Initial Study/Mitigated Negative Declaration Gateway Center North 950 E. 33rd St. & 3177 California Ave. (SCH #2021030665)

Addendum

The Developer (Applicant) is proposing minor modifications to the original Area Three (5,000 square-foot drive-through restaurant space). The proposed development would include construction and operation of a 1,025 square-foot Dutch Bros Coffee drive-through facility, located on a 0.77-acre parcel (APN: 7148-005-047). The parcel proposed for the Dutch Bros Coffee is currently developed as part of the parking lot for the existing Gateway Center North Shopping Center. The site has an approved specific plan, Gateway Center North Specific Plan (SP-12), which was approved in May 2021 with the adoption of the ISMND. The proposed development would occupy the 5,000 square-foot drive-through restaurant space (Area Three) originally proposed in the Specific Plan (SP-12) and ISMND. Existing requirements for the Area Three drive through space include the following Conformity standards as set in §20.32.320 through §20.32.390 of the Signal Hill Municipal Code.

Figure 1: Original proposed site layout per Initial Study/Mitigated Negative Declaration Gateway Center North 950 E. 33rd St. & 3177 California Ave

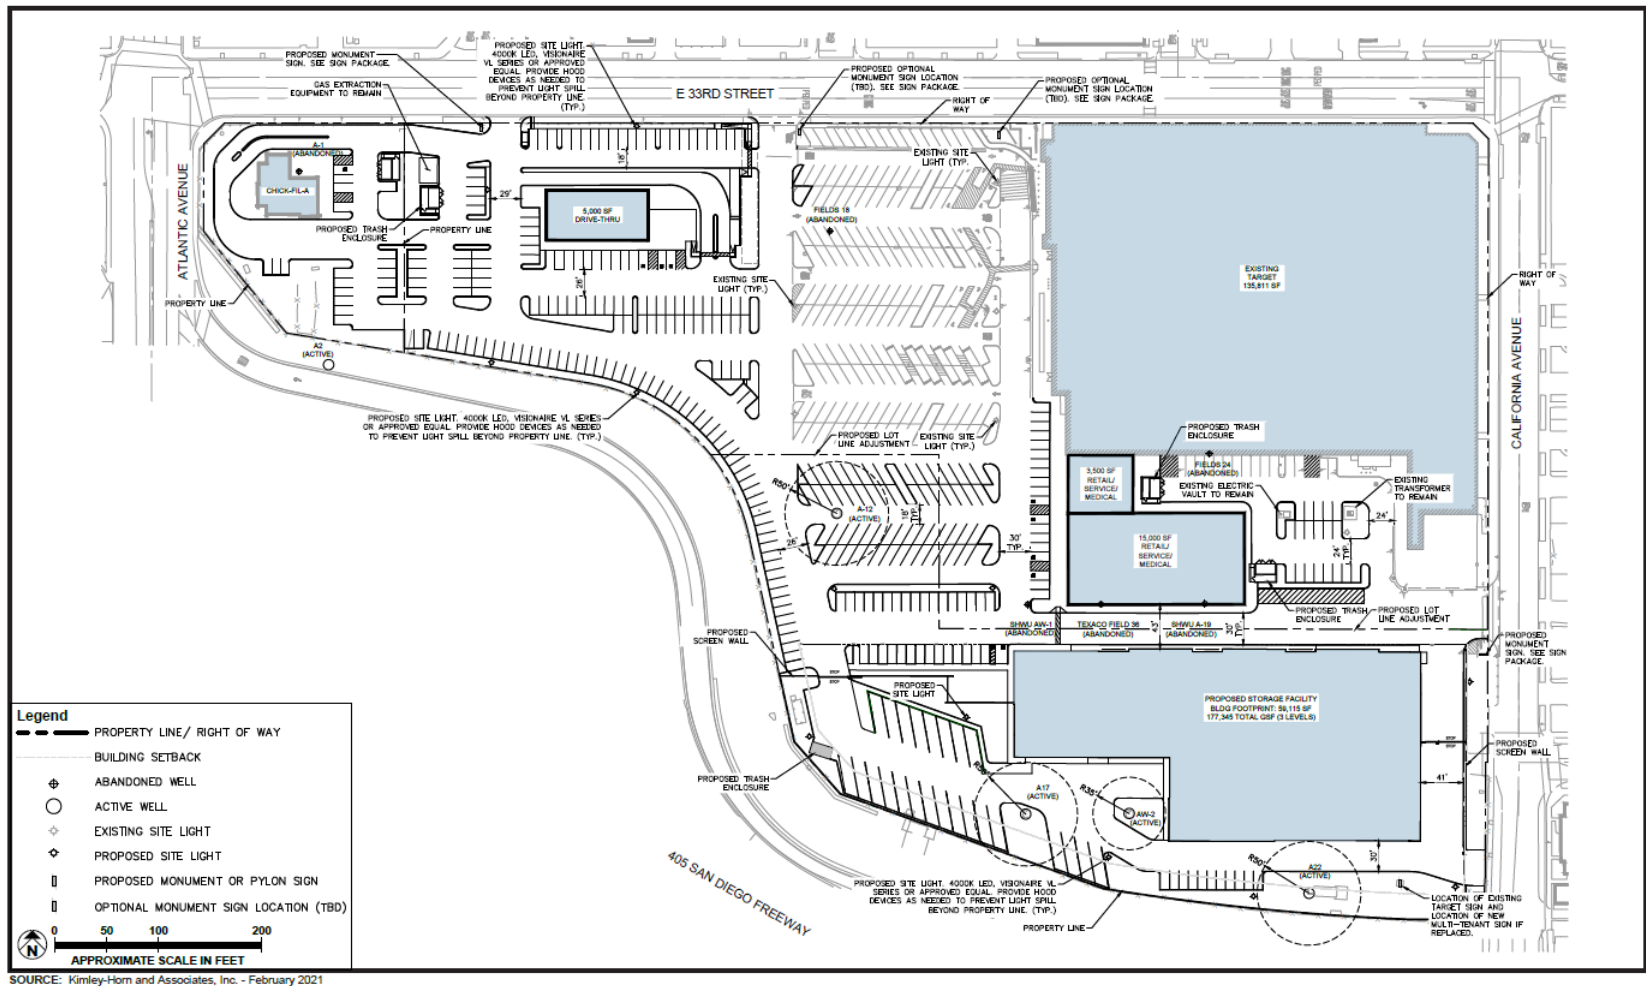
The Project as stated in the ISMND is a 13.63-acre site located on the south side of E. 33rd Street between Atlantic and California Avenues in the North End neighborhood. The Project consisted of the following components to be built in phases: renovation of the existing Target store with new exterior features but no increase in floor area; construction of a new three-story, 177,345 square-foot self-storage facility on the southern parcel; construction of a new commercial space adjacent to the existing Target and totaling 18,500 square feet; and construction of a new 5,000 square-foot drive-thru restaurant.

The Project also includes a variety of site improvements including surface parking for 493 vehicles. Vehicular access would be via two driveways on 33rd Street and one driveway on California Avenue. The 18,500 square foot commercial space and 5,000 square-foot drive through restaurant where to be built as tenants are secured and not part of the initial building phase. The original proposed site layout analyzed in the ISMND is provided in Figure 1.

Figure 3 Enlarged Site Plan

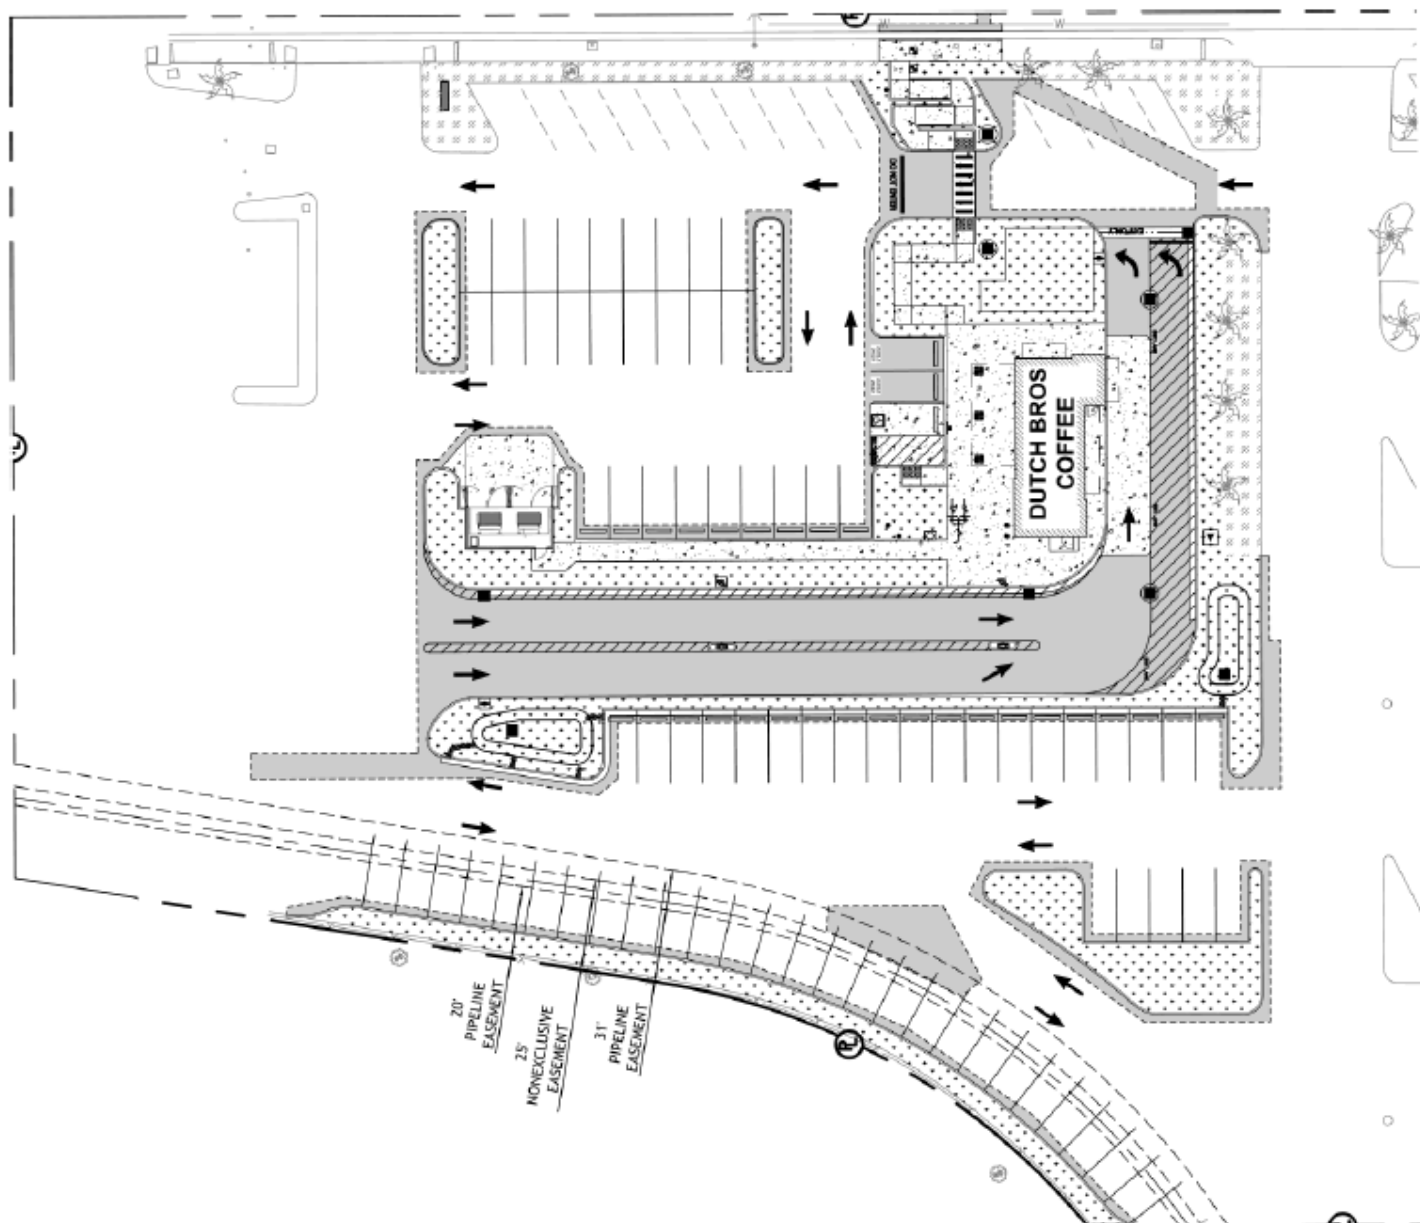
The applicant proposes modification to the Area Three portion of the site plan originally designed as 5,000 square-foot drive-through restaurant space. The proposed development would consist of construction of a Dutch Bros Coffee drive-through facility. The development will not include any indoor seating. Instead, the Project will provide drive-through service, order-ahead pick-up, and a designated walk-up ordering area. A covered walk-up service window will be located on the west side of the building, opposite the drive-through service window for pedestrian traffic. The Dutch Bros Coffee drive-through will operate seven days a week, with typical hours of operation of 5:00 a.m. to 11:00 p.m. The proposed development will incorporate landscaping enhancements including combination of shrubs, groundcovers, and trees consistent with the rest of the developed shopping center. Changes from the original site design include:

- A reduction in building footprint from 5,000 sq ft to 1,025;
- A change in orientation of the drive through from a southern entrance and eastern exit to an eastern entrance and northern exit, with an extended two-lane portion of the drive through line;
- Movement of the proposed trash enclosure to along the drive through lanes;
- Accommodate an average of 754 trips per day;
